Delegation Request

To: [REDACTED]
Subject: RE: [EXTERNAL]Delegation Request Form - Committee of Adjustment Application
Bramalea Islamic Culture Centre A-2025-0113 - 89 MillStreet North

Request for Appeal against Committee of Adjustment Approval to
Proceed with Site Plan Review of Application A-2025-0113 -
89 Mill Street North

1 SITE PLAN - PROPOSED
A0-002 1:84

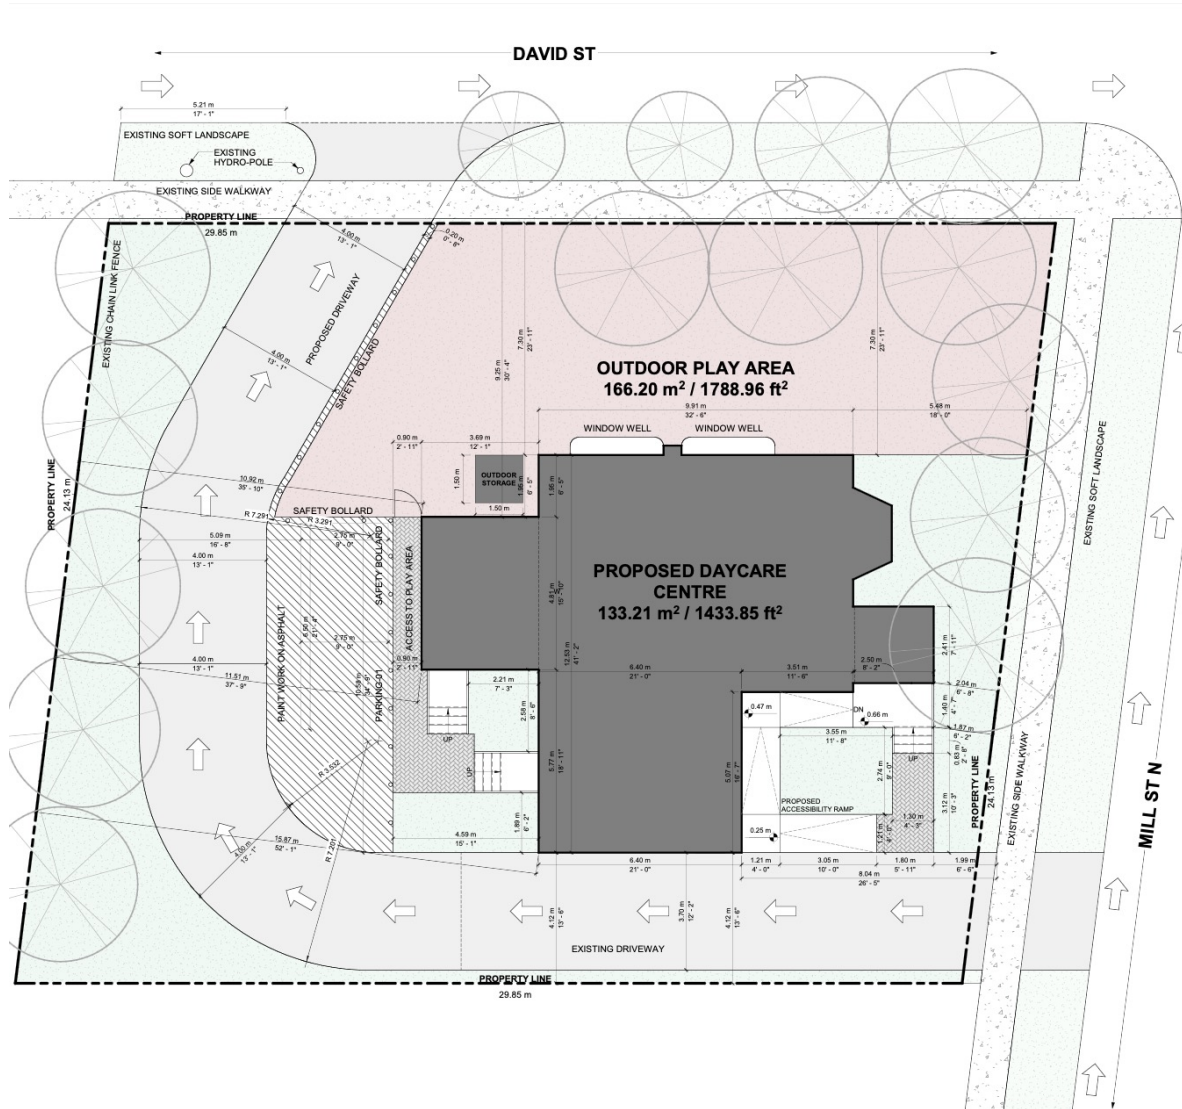
The Application details a childcare with 57 children and 10 staff including the supervisor. It also shows only 4 proposed Tandem Parking Sports on the subject property. The drawing indicates a 'Kiss and Ride' provision showing a narrow driveway entering the property from Mill Street and exiting the property from David Street.

Assuming that this is approved, the driveway will not accommodate more than 5 vehicles before the first vehicle stops at the main entrance to the proposed Daycare to drop off a child.

This would result in traffic from parents waiting to drop off their child being backed onto Mill Street. There are 57 children so we can consider at least 30 to 35 vehicles at any given period between the hours of 7.00 am to 9.00 am and again from 4.00 pm to 6.00 pm on weekdays.

The proposed 'Kiss and Ride' drive-through will be covered with 4 feet of snow in the winter. There is no space for shovelling all this snow as this driveway barely allows one vehicle to go through with the fencing for the neighbouring property on one side, and the daycare building on the other. **Where will all this snow be put away ?**
